**Illinois Tollway M-ITS Base Sheet Revisions**

Section M		Base Sheet Drawings	
Drawing	Modification Summary	Effective: 2021-03-01	
	New Sheet  Retired Standard		
<b>Pole Assembly (ITS)-Series 1000</b>			
<b>M-ITS-1000</b>	<b>Elevation Views Pole Mounted ITS Element Assembly</b>		
	<ul style="list-style-type: none"> <li>. Sheet 1of3: Added title for one section detail; Added note on wires from solar panels to battery box then to ITS enclosure then Cat6 cables to ITS devices installed on the ITS pole</li> <li>. Sheet 2of3: Added title for ITS Disconnect Switch Cast-in place</li> <li>. Sheet 3of3: Added new assembly detail for ITS Disconnect Switch Pre-cast (simplified installation)</li> </ul>		
<b>M-ITS-1001</b>	<b>General Notes Pole Mounted ITS Element Assembly</b>		
	<ul style="list-style-type: none"> <li>. Added Note 22.: Cables shall enter poles through a gromet. Gromet size shall be chosen so that the center hole forms a water tight seal around the cables</li> </ul>

**100 FT. MONOPOLE CLOSED CIRCUIT TELEVISION (CCTV) CAMERA TOWER**

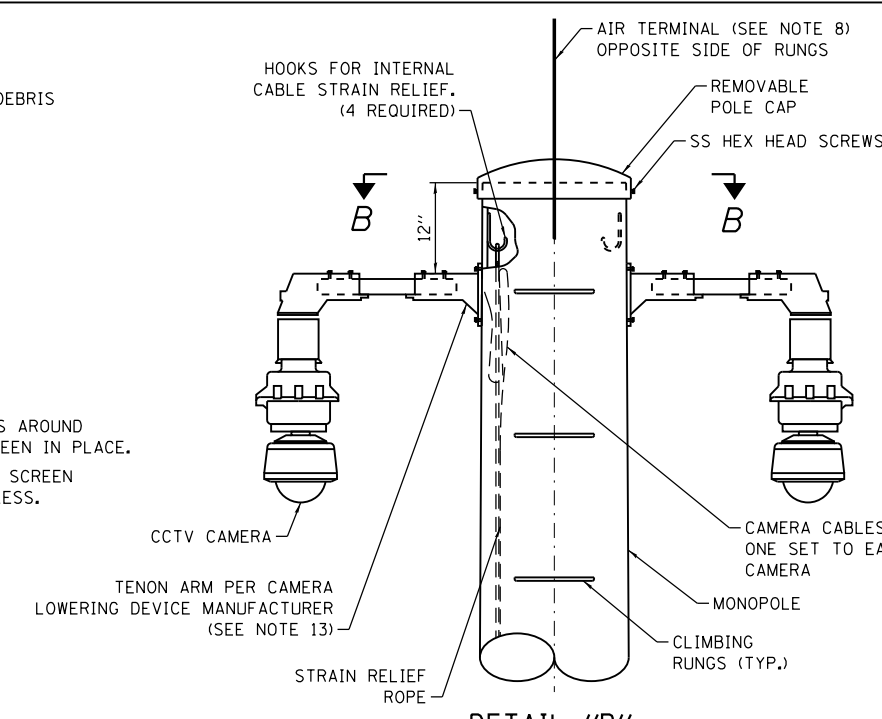
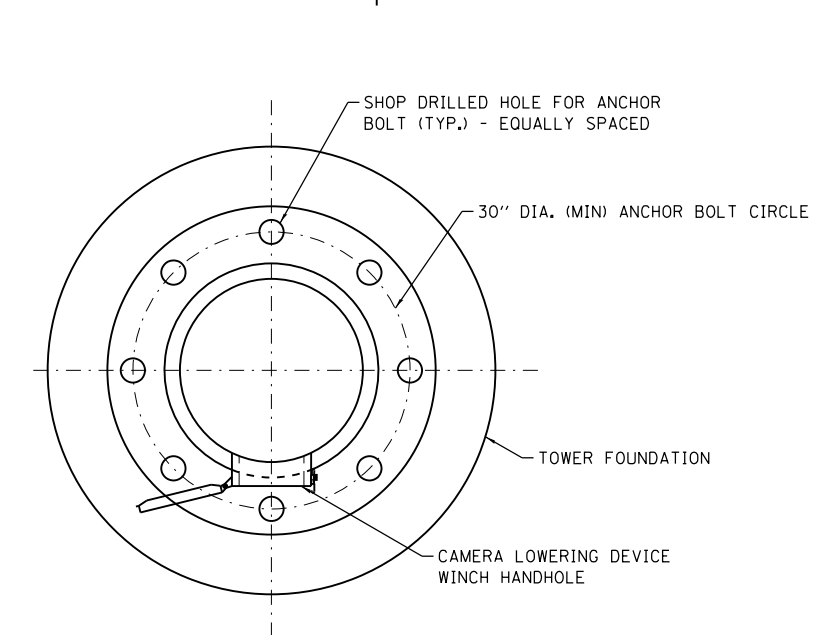
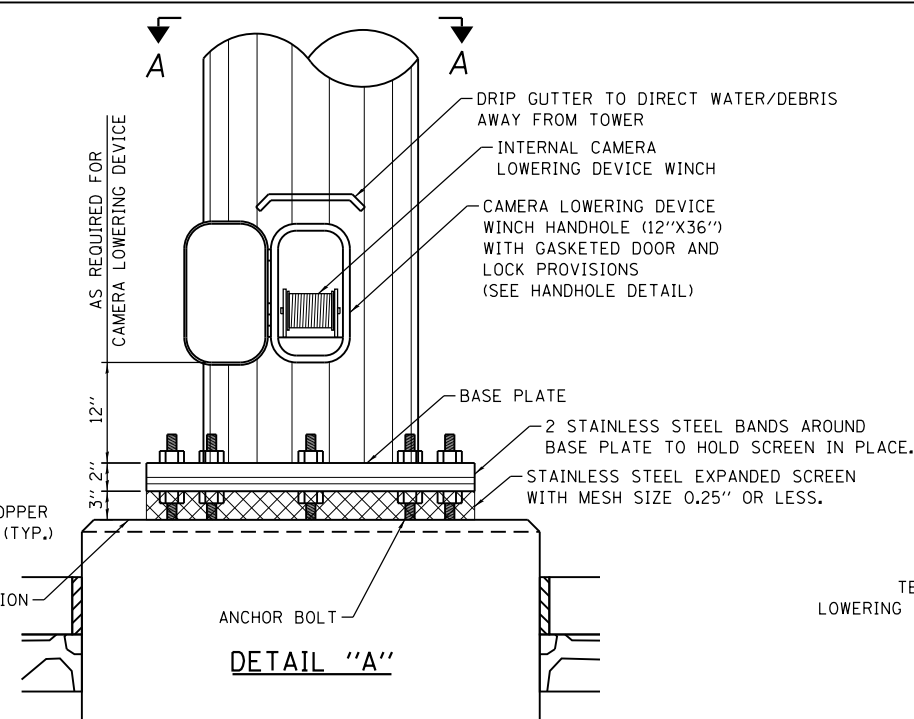
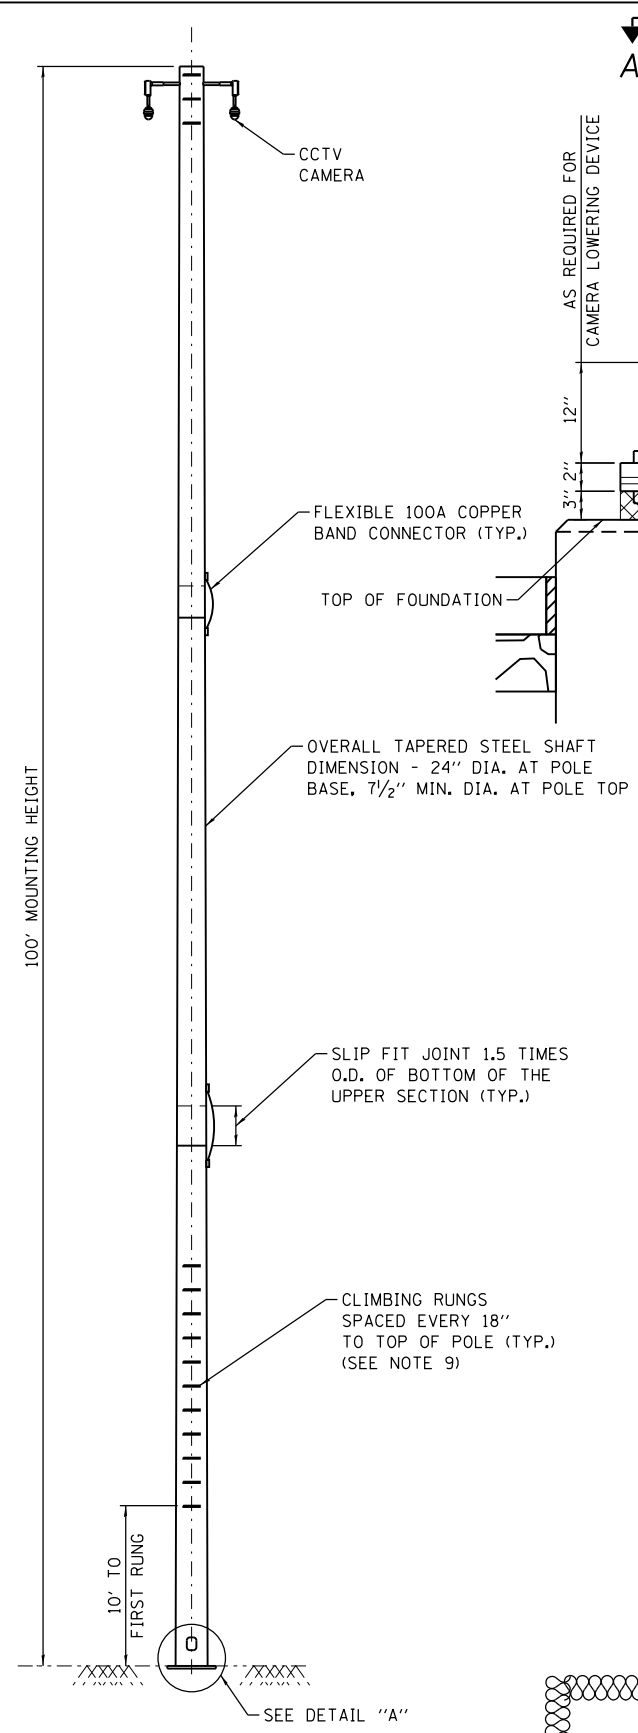
. Sheet 1of4: Added details for ITS and support for ITS Enclosure foundation: 16" Dia. X 4' @ 3000PSI Circular Concrete Foundation . Sheet 4of4: Added details to install the ITS Enclosure and ITS Disconnect Switch onto the concrete slab of 100 foot monotube
<b>Video Power Junction Box (ITS)-Series 2100</b>	
<b>M-ITS-2100</b>	<b>Video Power Junction Box Model A: 4 PoE CCTV arrangment without communication switch</b>
	. New drawing created to standardize Video Power Junction Box arrangment - Without Cisco switch when the box is installed and can use Cat 6 cables when distance is less than 300 feet from Plaza Communication room
<b>M-ITS-2101</b>	<b>Video Power Junction Box Model B: 4 PoE CCTV arrangment Cosco 4000 switch</b>
	. New drawing created to standardize Video Power Junction Box arrangment - With Cisco 4000 switch when the box is installed at a distance greater than 300 feet from the Cisco switch in the Plaza Communication Room
